PLANNING COMMISSION PACKET

December 2, 2022

P-22-20

Request to amend the master development plan for Mountain Brook Junior High School, specifically the athletic field/tennis complex.

GUNN'S RESURVEY OF MOUNTAIN BROOK ESTATES CANTERBURY SECTOR

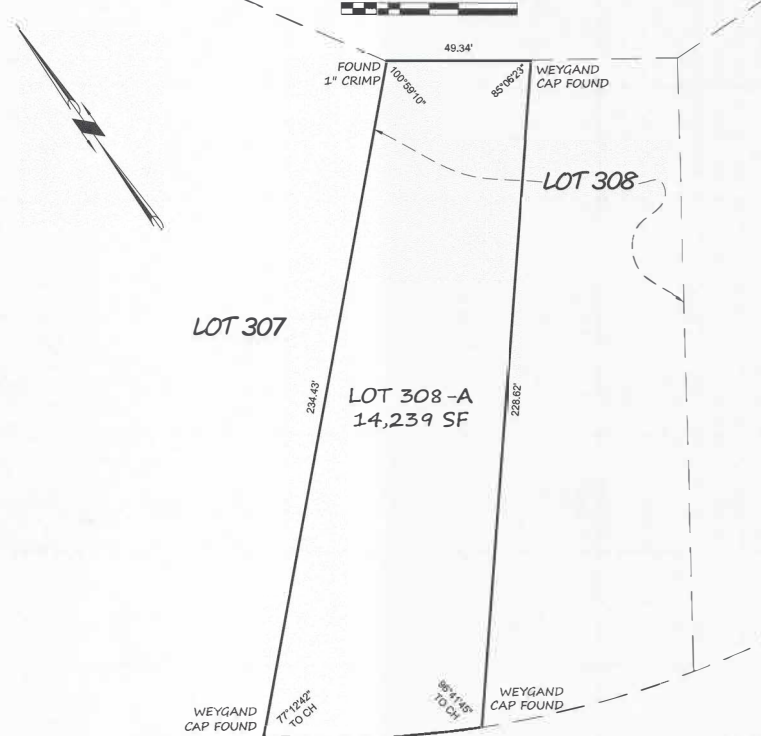
- ✓ “Clean-up” resurvey combining portions of legacy lots.
- ☑ **May be approved as a final plat;** the following corrections for the final plat are required by the Subdivision Regulations, and **are suggested as conditions of approval:**

1) Indicate City of Mountain Brook PC Chairman and PC Secretary on signature blocks.

- ✓ Meets the Zoning Regulations for the Residence A district.
- ✓ **Overall layout is acceptable**, with the final plat to fully comply with all applicable requirements of the Mountain Brook Subdivision Regulations.
- ✓ No floodplain present.
- ✓ No relevant history or prior cases.

FLOOR PLAN

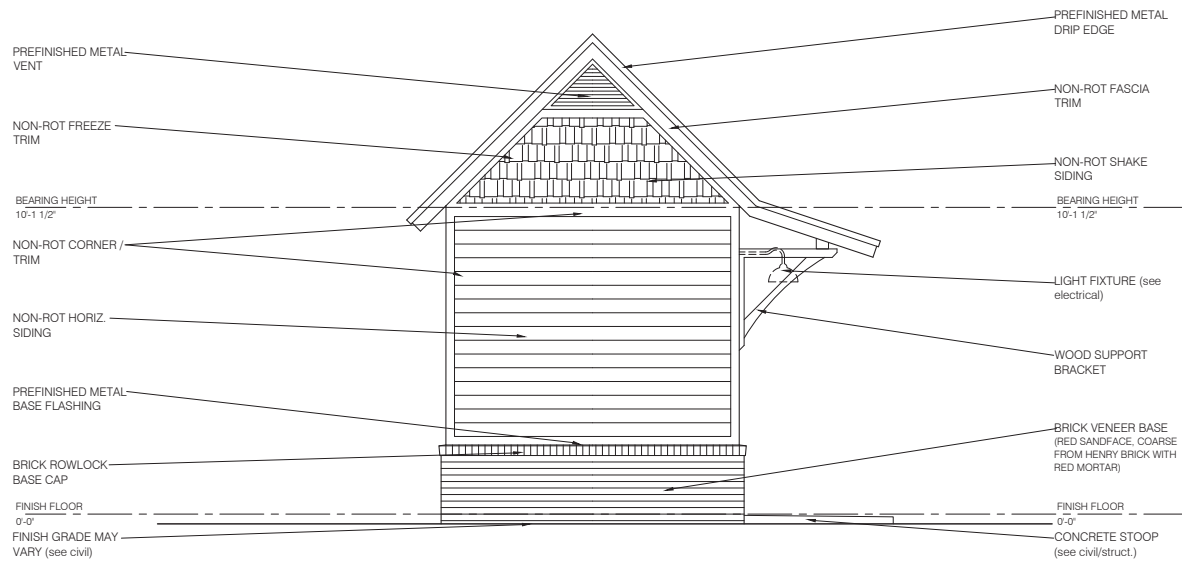
A new restroom/storage facility is proposed along the north side of the field; see attached floor plan and elevations.

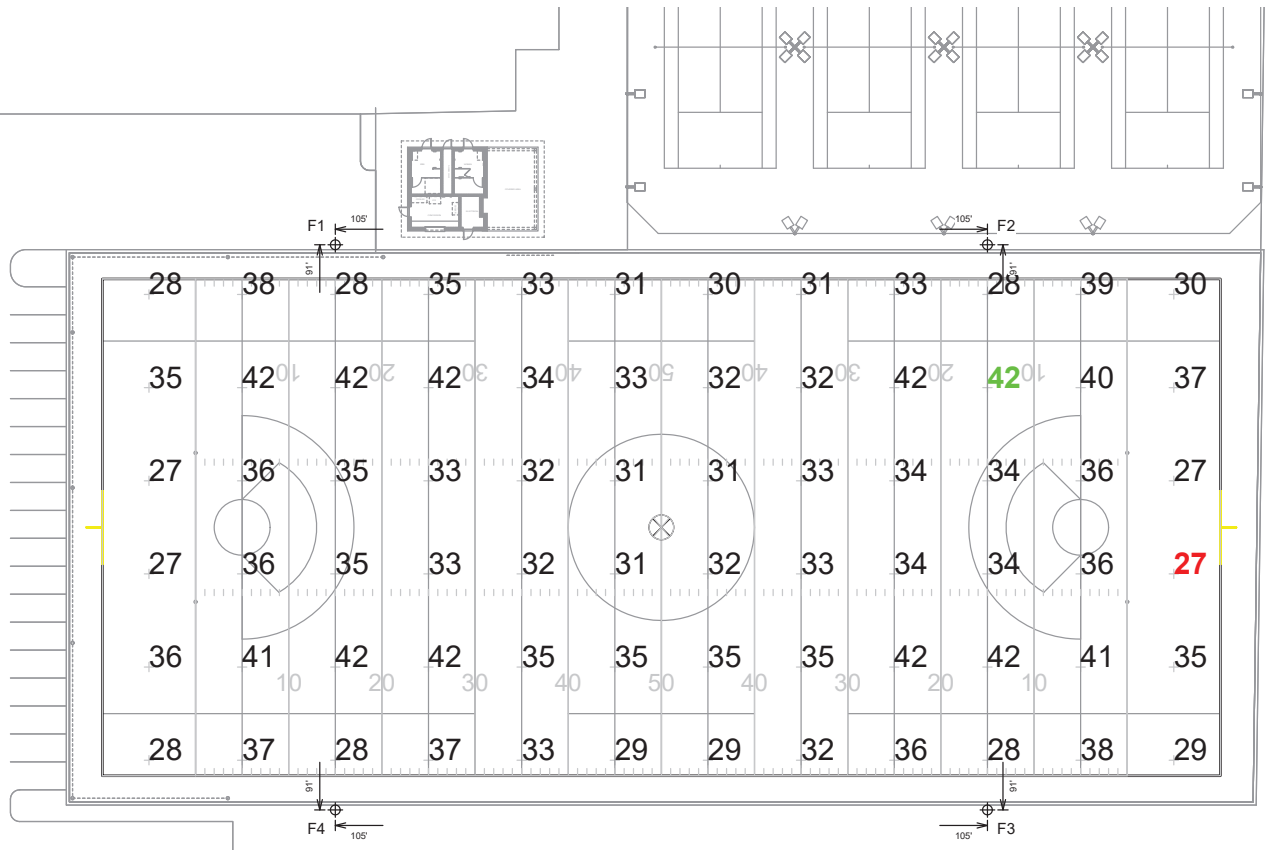
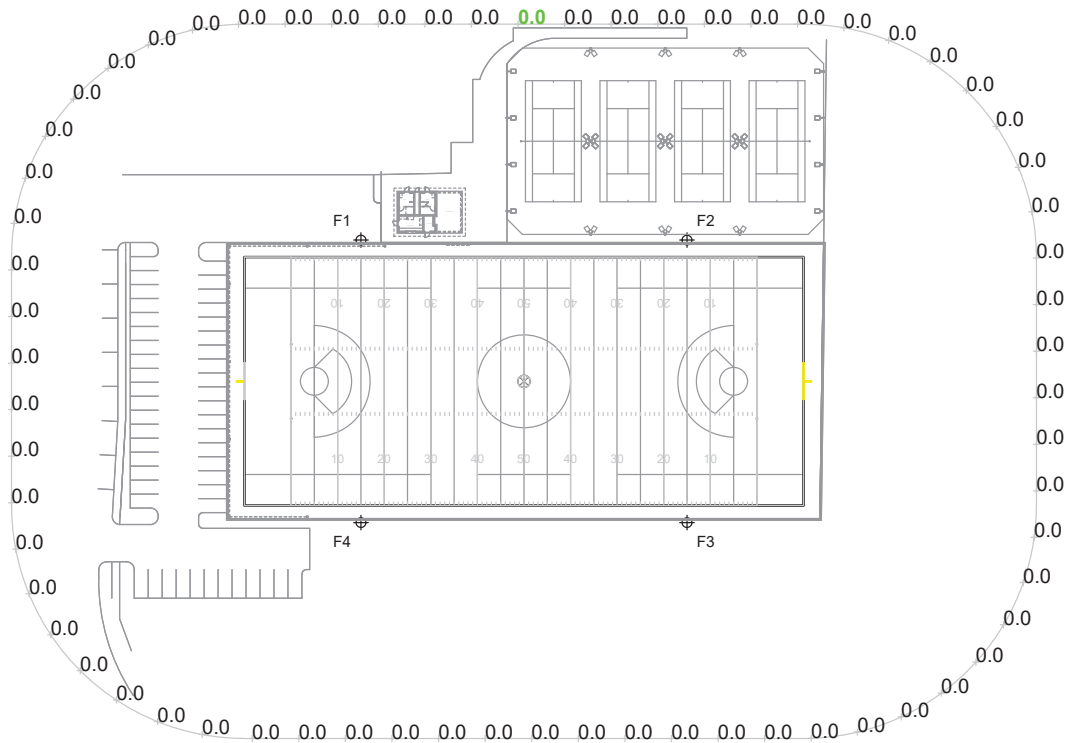
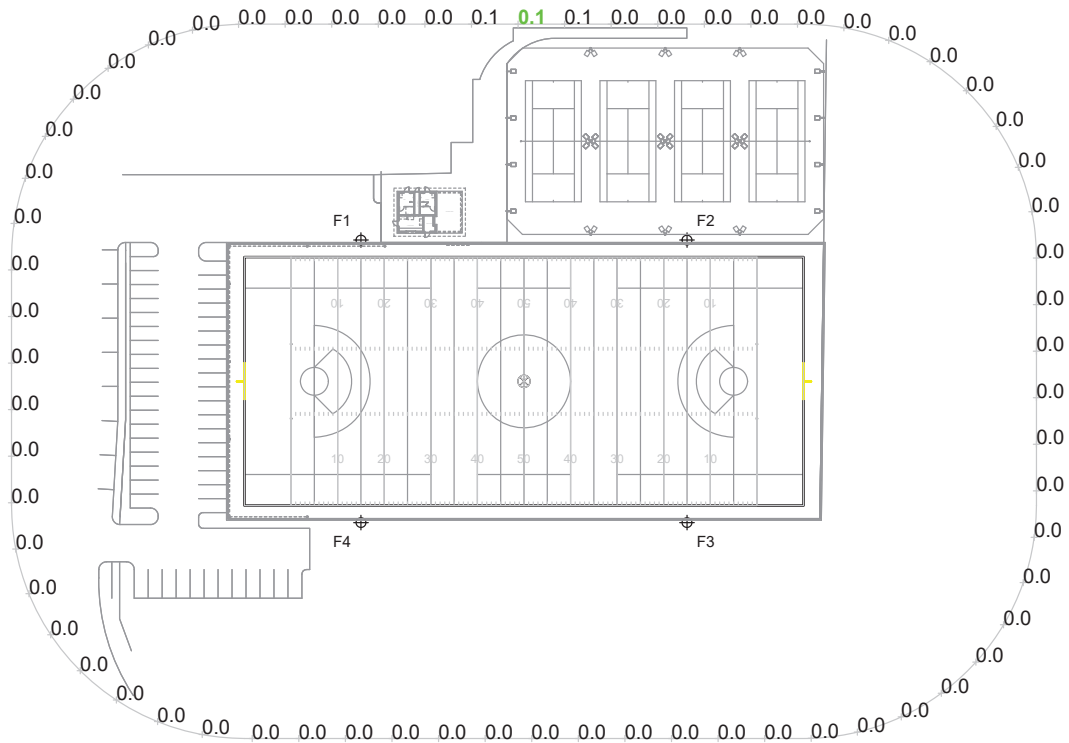
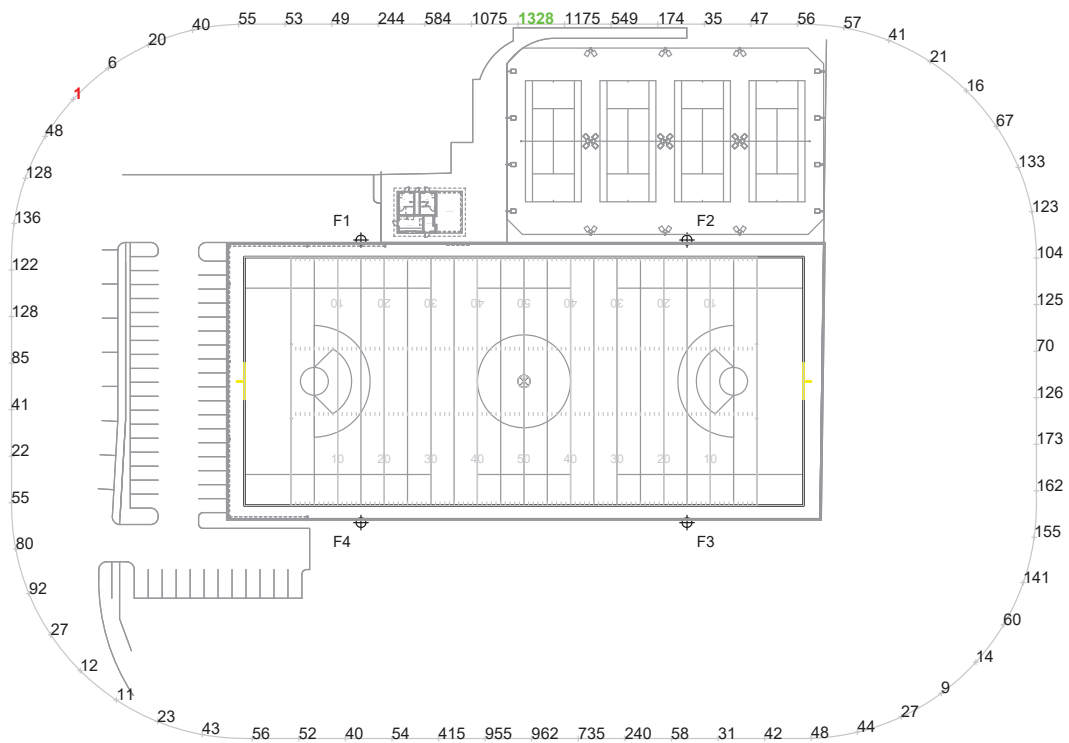
In an aerial view of the existing fields it appears that there are 6 light poles. The proposed field lighting includes 4 poles (60 feet high). There is to be 20-foot tall protective netting, primarily along the east and west ends of the new field (shown in red on the attached site plan); and a black chain-link fence along the north and south sides of the field (shown in yellow on the attached site plan). The planning commission may find it helpful to request of the applicant photographs of pole material and netting material/height in other similar applications.

While the attached illumination studies depict details about light spillage in the context of the field and tennis court, there is no specific reference to the spillage and adjoining properties (or properties across Overbrook Road). The planning commission may find it helpful to request that the illumination grids be superimposed over an aerial showing adjoining properties, and perhaps also that the distance of the “ovals” be dimensioned on the study illustrations as to their distance from the edge of the fields and tennis courts, and as to their distance to adjoining property lines and to residential property lines across Overbrook Road.

Staff has been unable to ascertain any description of when the field lighting currently occurs (typical days of week and typical hours of the evenings), nor to ascertain how this may change with the new proposed project. The planning commission may find it helpful to request details on how many days per week (and during what hours) the lighting is currently employed, and how it is proposed to be employed in future.

DRAINAGE PLAN

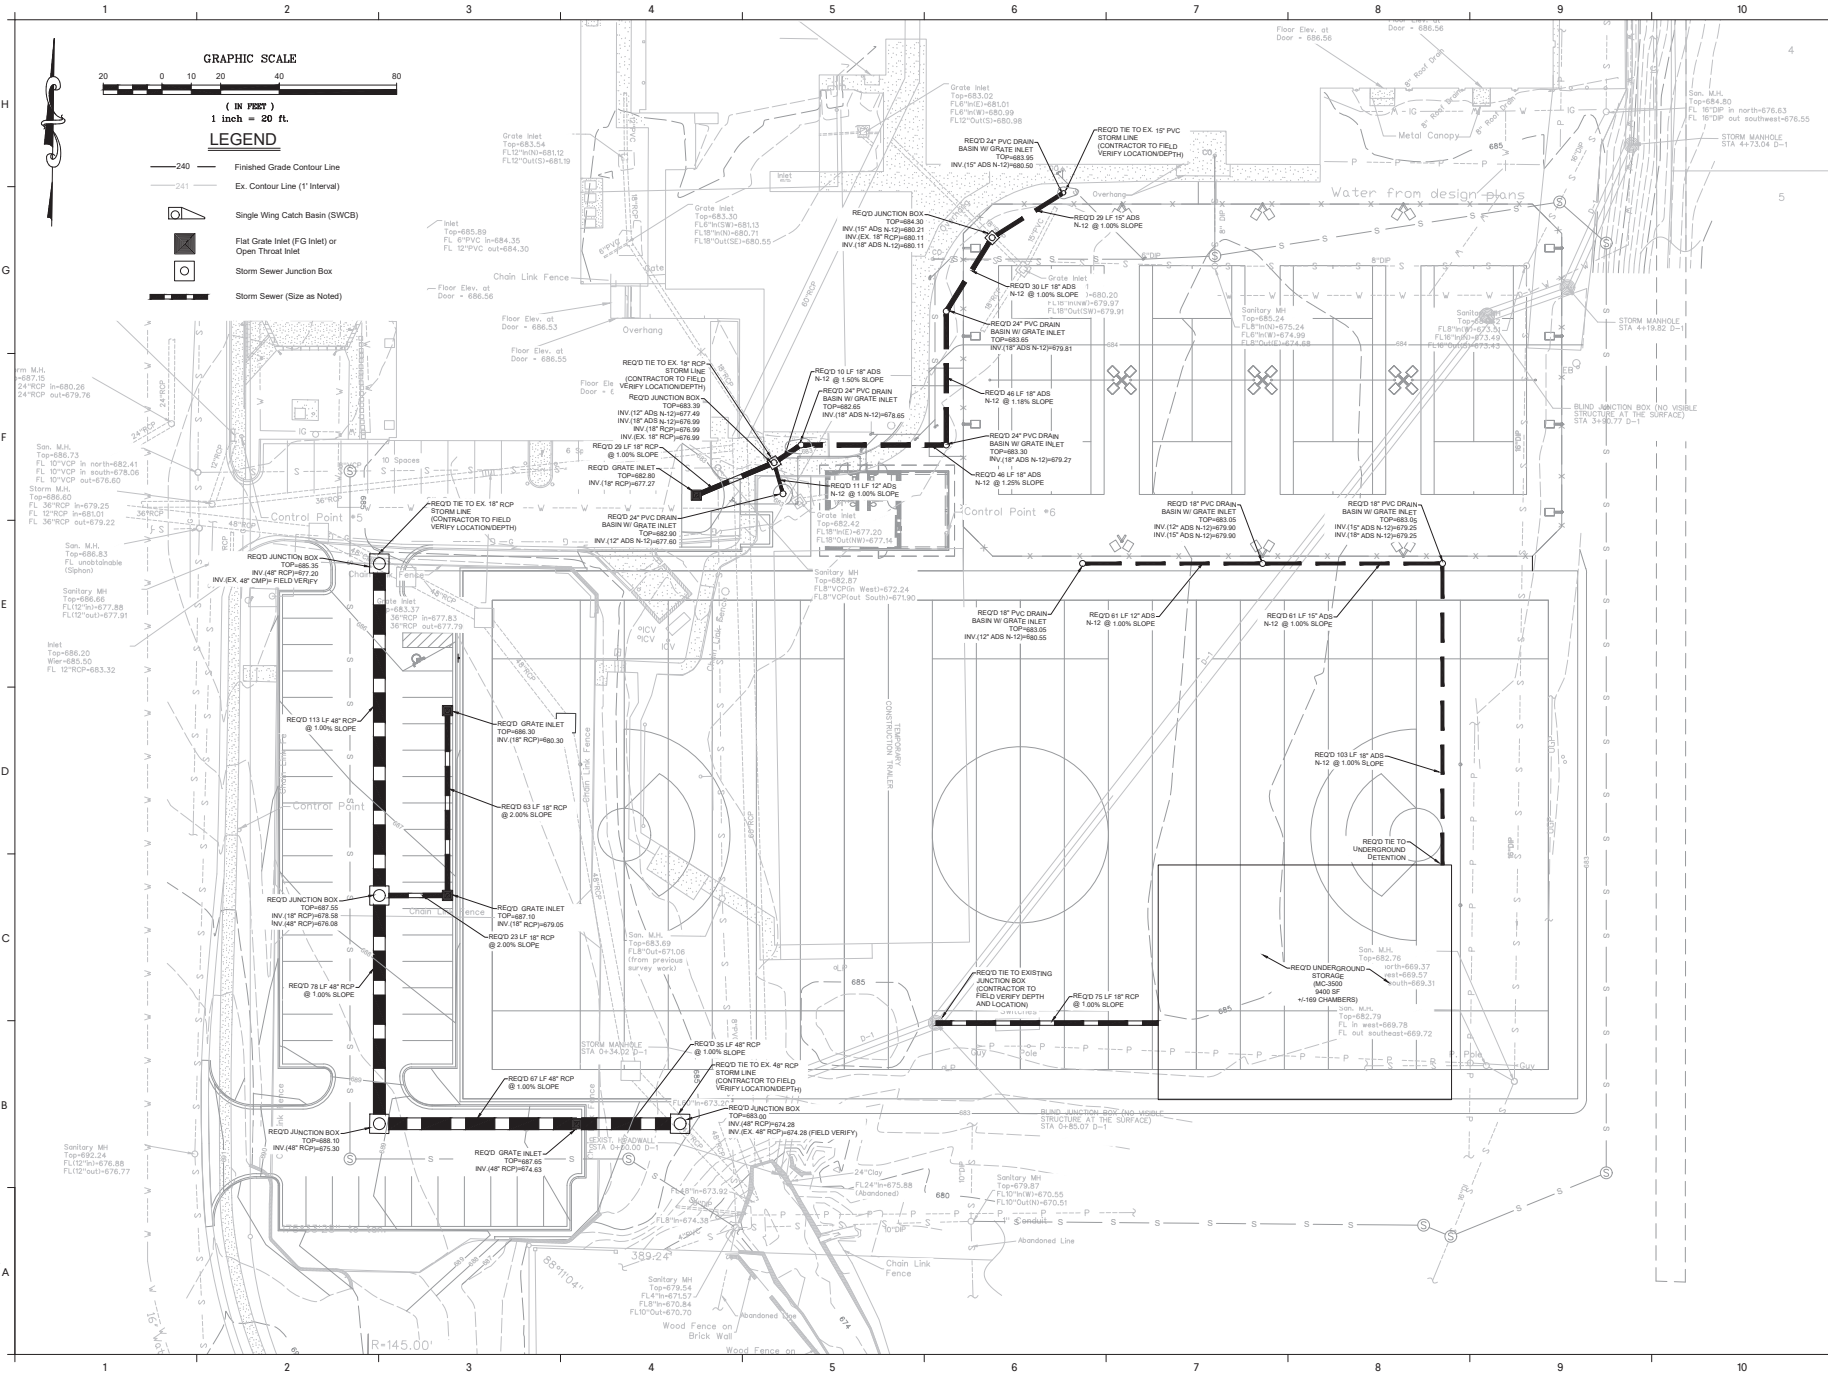
Attached are the topographic survey and the proposed drainage plan. The topographic survey indicates a grade change of roughly 2-7 feet from the north end of the field complex to the southernmost property line of the school (varies from east to west). However, drainage in general is concern of adjoining property owners to the south, and specifically as it relates to any potential increase in runoff from the turf conversion, and from the increased impervious area related to the tennis court relocation and new parking lot layout.
